**SURVEY FOR
ABE KURTZ**

PART OF THE SW. 1/4
OF SEC. 16, T-22, R-17,
MONROE TWP., RICHLAND
CO., OHIO.

Lot Split Application

HEALTH DEPT. MAP

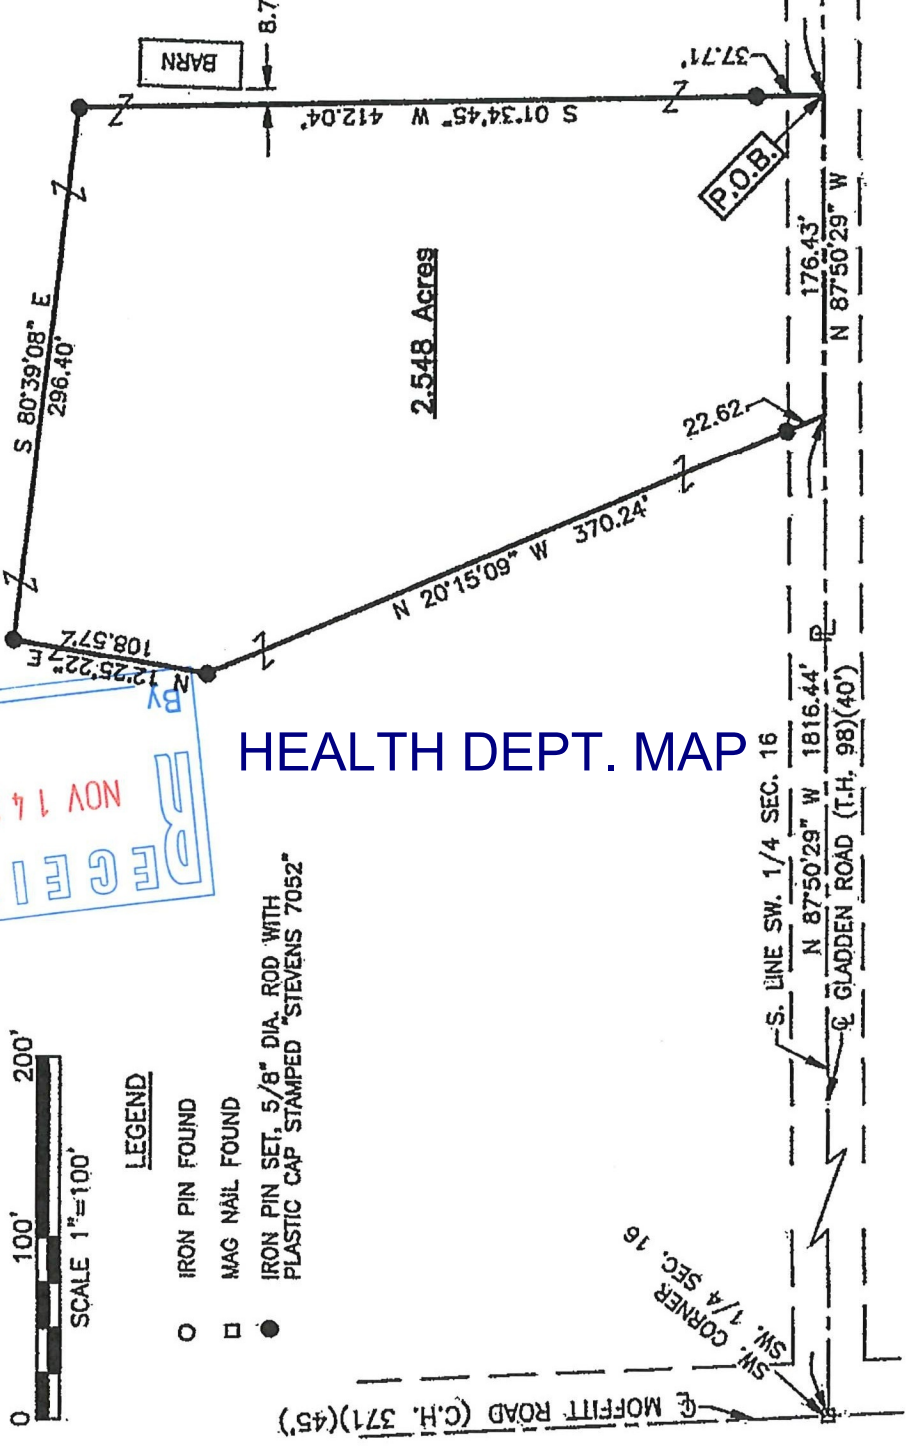
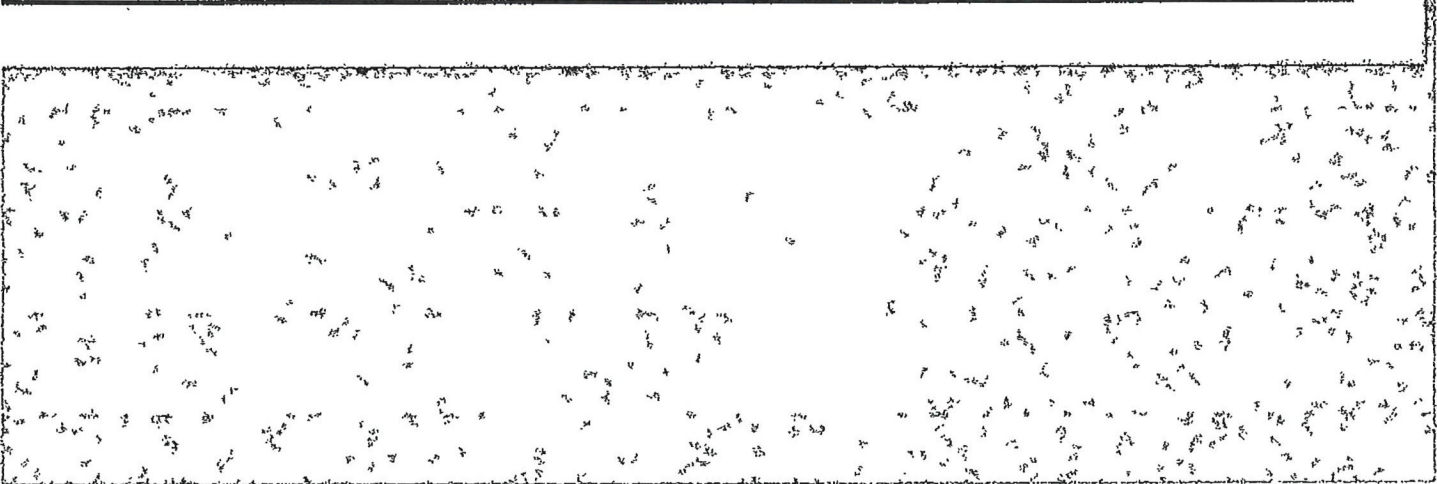
- AREAS DESIGNATED FOR INSTALLATION AND/OR REPLACEMENT OF A SEWAGE TREATMENT SYSTEM SHALL BE UNDISTURBED AND PROTECTED FROM DAMAGE OR DISTURBANCE. DAC 3701-29-15(P)(1)
- INFORMATION PROVIDED WITH THE LOT SPLIT APPLICATION DID NOT INDICATE ANY POTENTIAL OR EXISTING EASEMENTS OF ANY TYPE.
